THE MANITOBA WATER SERVICES BOARD

CONTRACT NO. M.W.S.B. 1413

City of Selkirk Wastewater Treatment Plant

ADDENDUM NO. 4

Sketch 1

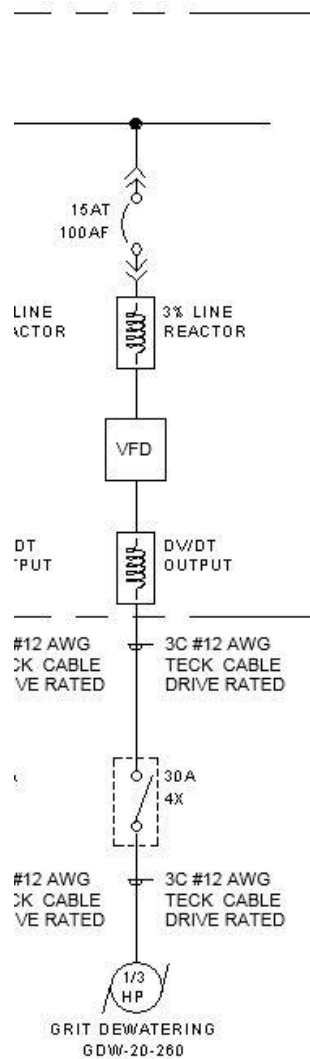
- 4.9 Reference Drawing 05-E003:
- Conductors feeding panels DP-204A and DP-204B shall be 4 conductor.
- 4.10 Reference Drawing 05-E004:
- Replace Grit Removal Unit/Grit Washing GRC-20-210 circuit, with the circuit shown in Sketch 1.
